# Rockwell service bulletin

Service Bulletin No. SB-AG-1  
November 30, 1973

## INSPECTION OF VERTICAL FIN STRUCTURE

EFFECTIVITY: MODEL S-2D, SERIAL NO'S 1311D THRU 1379D AND 1381D THRU 1415D

Figure 1.

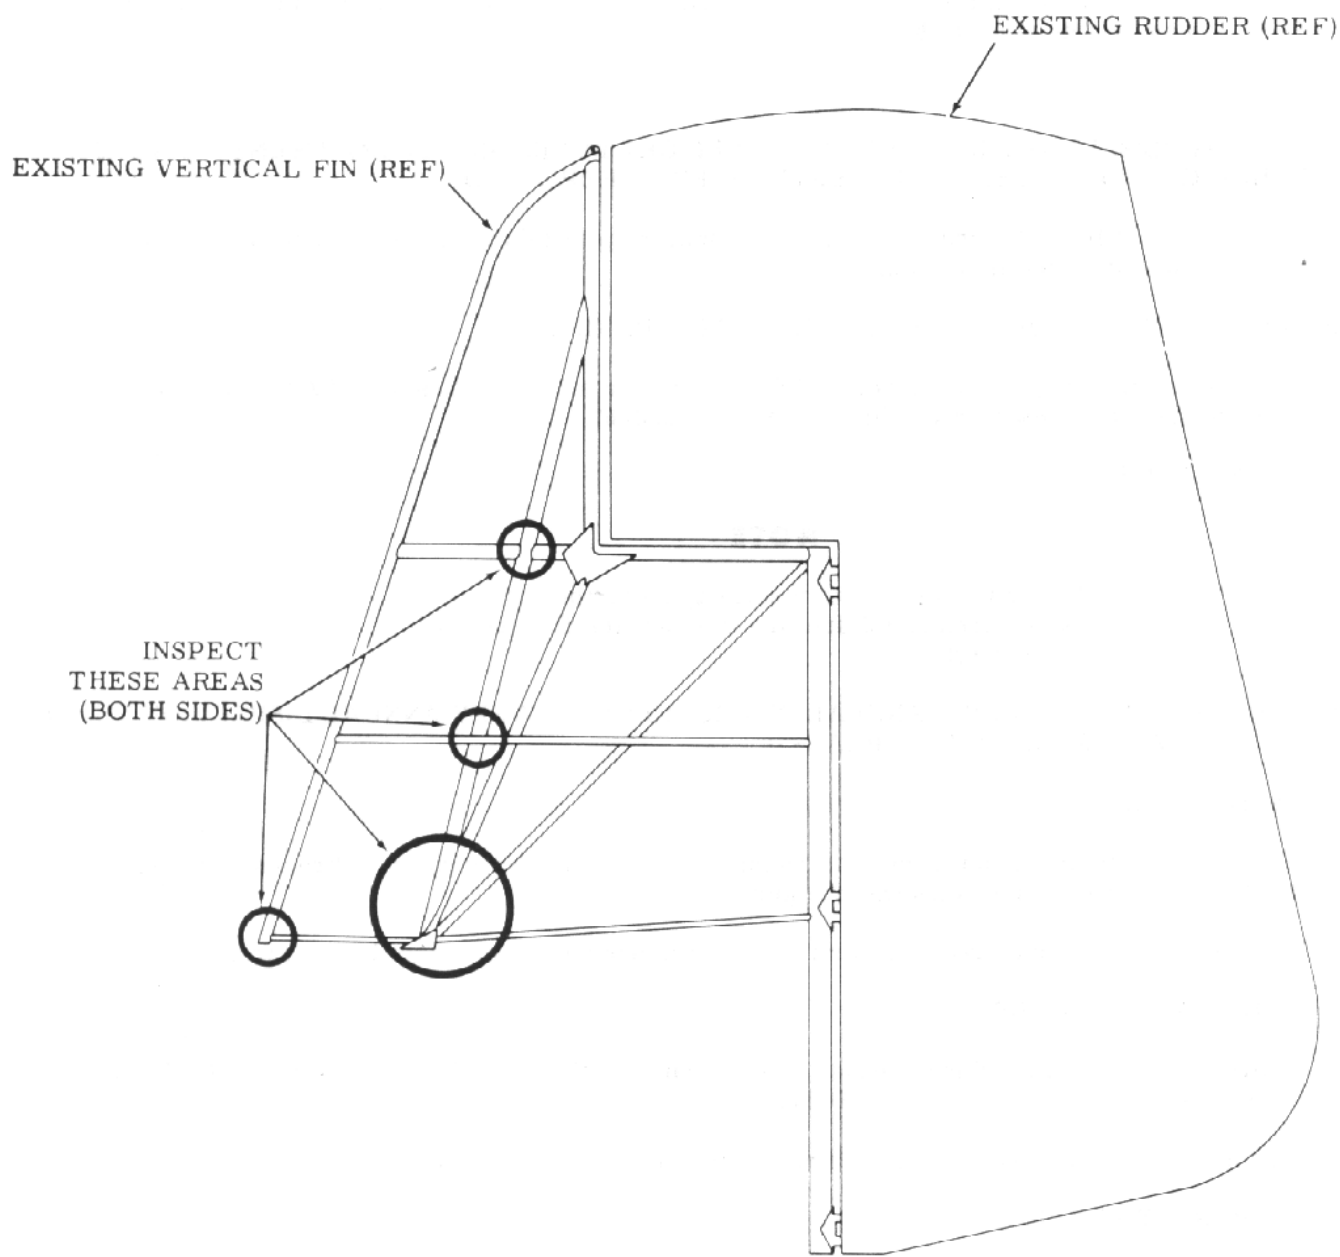
PURPOSE: Service investigation has revealed six (6) vertical fin failures have occurred on both the left and right lower horizontal support tubing of the vertical fin at the leading edge weld cluster and aft of that position at forward vertical fin attach point. This Service Bulletin is being issued to aid the operator during inspection of the vertical fin area to prevent future fin failures.

- a. Visually inspect vertical fin and manually press horizontal support tubing in area shown in Figure 1. to immediately determine if tubing is broken.
- b. If no breaks are detected in tubing, proceed to AIRCRAFT RECORDS.
- c. If breaks are detected in tubing, remove vertical fin and repair in accordance with FAA Advisory Circular AC-43.13-1 or replace with new vertical fin Part No. 5-4030-67.
- d. Proceed to AIRCRAFT RECORDS.

- a. Remove existing vertical fin.
- b. Remove fabric from vertical fin and inspect all welds on vertical fin for cracks or breaks. Particular attention should be directed to areas shown in Figure 1.
- c. If no cracks or breaks are found, recover vertical fin with new fabric and install on aircraft.
- d. Proceed to AIRCRAFT RECORDS.
- e. If cracks or breaks are found in tubing, repair in accordance with FAA Advisory Circular AC 43.13-1 or replace with new vertical fin Part No. 5-4030-67.
- f. If repairs are made, recover vertical fin with new fabric and install on aircraft.
- g. Proceed to AIRCRAFT RECORDS.
